Modification Bulletin

Model: Mojito Finisher SR740	Date: 06-Jun-00	No.: MB312001a

Modified Article: Ball Bearing				Prepared by: M. Tsuyuki			
From: Technical Ser	vices Dept., GTS Division						
Reason for	Parts catalog correction	Vendor ch	ange	To meet standards			
Modification:	☑ To facilitate assembly	🗌 To improve	e reliability	()			
	Part standardization	Other

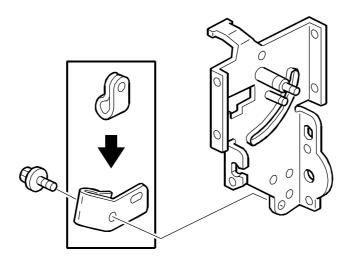
The shape of the clamp for the stapler harness has been changed as shown below to ensure proper orientation of the harness.

Old part	New part	Description	Q'ty	Int	Page	Index	Note
number	number						
11050062		Nylon Clamp – 6n	n - n-1	X/O	19	104	
	B3124160	Harness Clamp	0 - 1	70	19	*43

Harness: Stapler Tray: Motor

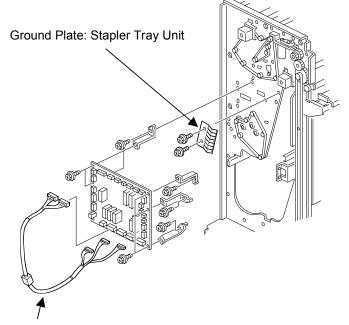
To further minimize the effect of electrical noise, the following parts have been added to the stapler tray.

- 1) Ground Plate
- 2) Ferrite Core (added to the motor harness)

Old part	New part	Description	Q'ty	Int	Page	Index	Note
number	number						
	B5861165	Ground Plate: Stapler Tray Unit	0 - 1		33		
B3125304 -		Motor harness – Stapler Tray	1 - 1	X/O	33	2	
	B 5865306	Harness: Stapler Tray: Motor	1 - 1	20	33	2	
04513006B		Tapping Screw - M3x6	n – n+2		33	105
